Refer to: HSA-10/SS-114

Thank you for your July 12, 2002, letter to Mr. Nicholas Artimovich requesting Federal Highway Administration (FHWA) acceptance of your company's NEX Tube as a breakaway component of a crashworthy mailbox support for use on the National Highway System (NHS). Accompanying your letter were photographs of your proposed mailbox mounting systems. You requested that we find the NEX Tube Mailbox Support System acceptable for use on the National Highway System under the provisions of National Cooperative Highway Research Program (NCHRP) Report 350 "Recommended Procedures for the Safety Performance Evaluation of Highway Features." On October 12, 2002, you provided additional information on a redesigned support for accommodating multiple mailboxes.

Single Mail Box Support
System

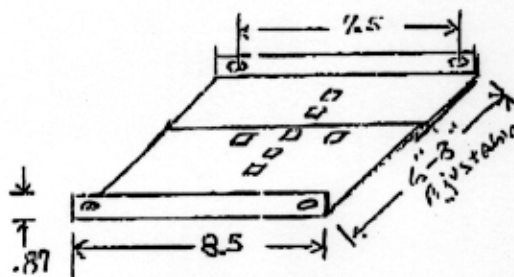
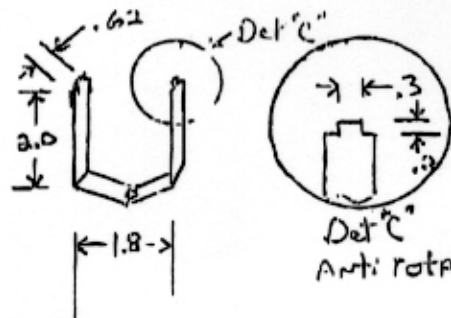
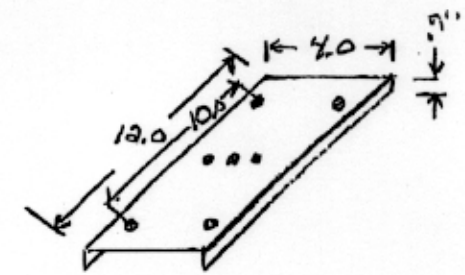
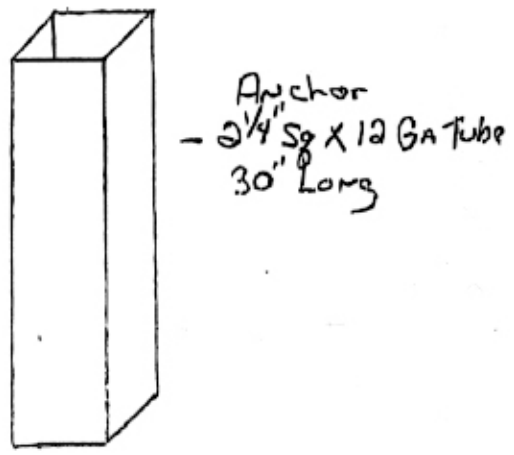
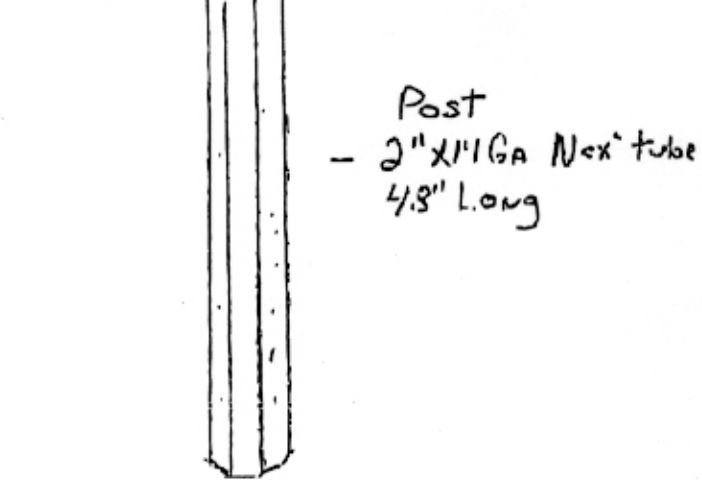
dual post support. You asked that we compare your socket design to the V-Loc system, which has already been tested as a mailbox support. We concur with your assertion that the same technology will be effective as a single/double mailbox support. Therefore, the NEX Tube sign support will be acceptable for use as a single/double mailbox support using the socket and wedge design as shown in the enclosed drawings.

The single/double mailbox support and the “inverted coat hanger” multiple mailbox support described above and shown in the enclosed drawings for reference are acceptable for use as Test Level 3 devices on the NHS under the range of conditions tested, when proposed by a State. The single box supports are considered crashworthy for conventional rural mailboxes weighing up to 5 pounds. The multiple box supports are considered crashworthy when boxes weighing up to 3.5 pounds each, are used.

Mult. Mail Box Support

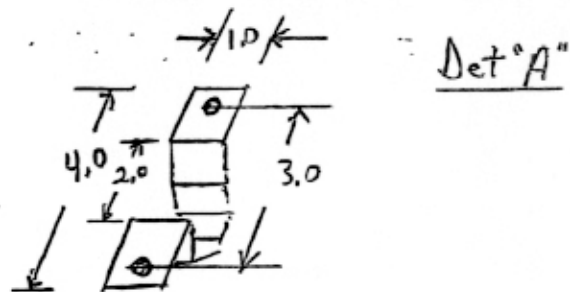
You also asked that we accept the NEX tube for use with multiple mailboxes using the “inverted coat hanger” arrangement. When the V-Loc system was tested with a multiple mailbox support (using 14 gage steel pipe in an “inverted coat hanger” arrangement) the occupant impact speeds were almost at the limit of acceptability. Because your design did not replicate the basic “closed loop” shape of the V-loc system, we were not as certain that five-box support using the NEX tube would meet the occupant impact velocity requirements. You have since redesigned your multiple mailbox support to replicate the “inverted coat hanger” arrangement, which we expect will perform in an acceptable manner.
